Product Change Notice (PCN)

PCN Number: PCN-0456183R-01

Product(s) Affected: *SJ-3502-SMT-TR*

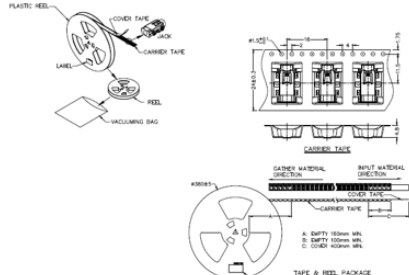
Description of Change: *New Factory Location. Product re-engineered for improved manufacturability and production yield. See image below for reference and check CUI Devices website for updated drawing. Cosmetic differences may be visible and not affect the form fit and function of the product.*

PREVIOUS CUI DETAIL / IMAGE				NEW CUI DEVICES DETAIL / IMAGE																																																					
<table border="1"> <thead> <tr> <th>DESCRIPTION</th> <th>MATERIAL</th> <th>PLATING/COLOR</th> <th colspan="2"></th> </tr> </thead> <tbody> <tr> <td>terminal 1</td> <td>stainless steel</td> <td>silver</td> <td colspan="2"></td> </tr> <tr> <td>terminal 2</td> <td>copper alloy</td> <td>silver</td> <td colspan="2"></td> </tr> <tr> <td>terminal 3</td> <td>copper alloy</td> <td>silver</td> <td colspan="2"></td> </tr> <tr> <td>housing</td> <td>PA8T (UL94V-D)</td> <td>black</td> <td colspan="2"></td> </tr> </tbody> </table>				DESCRIPTION	MATERIAL	PLATING/COLOR			terminal 1	stainless steel	silver			terminal 2	copper alloy	silver			terminal 3	copper alloy	silver			housing	PA8T (UL94V-D)	black			<table border="1"> <thead> <tr> <th>DESCRIPTION</th> <th>MATERIAL</th> <th>PLATING/COLOR</th> <th colspan="2"></th> </tr> </thead> <tbody> <tr> <td>terminal 1</td> <td>stainless steel</td> <td>silver over nickel</td> <td colspan="2"></td> </tr> <tr> <td>terminal 2</td> <td>copper alloy</td> <td>silver over nickel</td> <td colspan="2"></td> </tr> <tr> <td>terminal 3</td> <td>copper alloy</td> <td>silver over nickel</td> <td colspan="2"></td> </tr> <tr> <td>housing</td> <td>PA10T (UL94V-D)</td> <td>black</td> <td colspan="2"></td> </tr> </tbody> </table>				DESCRIPTION	MATERIAL	PLATING/COLOR			terminal 1	stainless steel	silver over nickel			terminal 2	copper alloy	silver over nickel			terminal 3	copper alloy	silver over nickel			housing	PA10T (UL94V-D)	black

DESCRIPTION	MATERIAL	PLATING/COLOR																																																							
terminal 1	stainless steel	silver																																																							
terminal 2	copper alloy	silver																																																							
terminal 3	copper alloy	silver																																																							
housing	PA8T (UL94V-D)	black																																																							
DESCRIPTION	MATERIAL	PLATING/COLOR																																																							
terminal 1	stainless steel	silver over nickel																																																							
terminal 2	copper alloy	silver over nickel																																																							
terminal 3	copper alloy	silver over nickel																																																							
housing	PA10T (UL94V-D)	black																																																							
<p>SOLDERABILITY</p> <table border="1"> <thead> <tr> <th>parameter</th> <th>conditions/description</th> <th>min</th> <th>typ</th> <th>max</th> <th>units</th> </tr> </thead> <tbody> <tr> <td>reed storage</td> <td>10-30°C, <10% humidity</td> <td></td> <td></td> <td></td> <td>°C</td> </tr> <tr> <td>reflow soldering¹</td> <td>see reflow profile</td> <td>255</td> <td>260</td> <td></td> <td>°C</td> </tr> <tr> <td>drying conditions²</td> <td>parts in reel: bake at 110°C for 4 hours parts removed from reel: bake at 110°C for 4 hours</td> <td></td> <td></td> <td></td> <td></td> </tr> </tbody> </table> <p>Note: 1. CUI Devices recommends to solder within 72 hours from opening vacuum packaging at a temperature <30°C & relative humidity <65%. 2. When exceeding floor life by >100 hours.</p> 				parameter	conditions/description	min	typ	max	units	reed storage	10-30°C, <10% humidity				°C	reflow soldering ¹	see reflow profile	255	260		°C	drying conditions ²	parts in reel: bake at 110°C for 4 hours parts removed from reel: bake at 110°C for 4 hours					<p>SOLDERABILITY</p> <table border="1"> <thead> <tr> <th>parameter</th> <th>conditions/description</th> <th>min</th> <th>typ</th> <th>max</th> <th>units</th> </tr> </thead> <tbody> <tr> <td>reed storage</td> <td>at relative humidity <60%</td> <td></td> <td></td> <td>40</td> <td>°C</td> </tr> <tr> <td>reflow soldering¹</td> <td>see reflow profile</td> <td>255</td> <td>260</td> <td>265</td> <td>°C</td> </tr> <tr> <td>drying conditions²</td> <td>parts in reel: bake at 40°C ±5°C for 72 hours parts removed from reel: bake at 40°C ±5°C for 10 hours</td> <td></td> <td></td> <td></td> <td></td> </tr> </tbody> </table> <p>Note: 1. It is recommended to reflow solder within 72 hours from opening vacuum packaging at a temperature <30°C & relative humidity <65%. 2. When exceeding floor life by >70 hours.</p> 				parameter	conditions/description	min	typ	max	units	reed storage	at relative humidity <60%			40	°C	reflow soldering ¹	see reflow profile	255	260	265	°C	drying conditions ²	parts in reel: bake at 40°C ±5°C for 72 hours parts removed from reel: bake at 40°C ±5°C for 10 hours

parameter	conditions/description	min	typ	max	units																																																				
reed storage	10-30°C, <10% humidity				°C																																																				
reflow soldering ¹	see reflow profile	255	260		°C																																																				
drying conditions ²	parts in reel: bake at 110°C for 4 hours parts removed from reel: bake at 110°C for 4 hours																																																								
parameter	conditions/description	min	typ	max	units																																																				
reed storage	at relative humidity <60%			40	°C																																																				
reflow soldering ¹	see reflow profile	255	260	265	°C																																																				
drying conditions ²	parts in reel: bake at 40°C ±5°C for 72 hours parts removed from reel: bake at 40°C ±5°C for 10 hours

PREVIOUS CUI DETAIL / IMAGE		NEW CUI DEVICES DETAIL / IMAGE	
<p>PACKAGING</p> <p>units: mm Reel Size: Ø330 mm Reel QTY: 1,000 parts per reel</p> 		<p>PACKAGING</p> <p>units: mm Reel Size: Ø300 mm Reel QTY: 1,000 parts per reel</p>
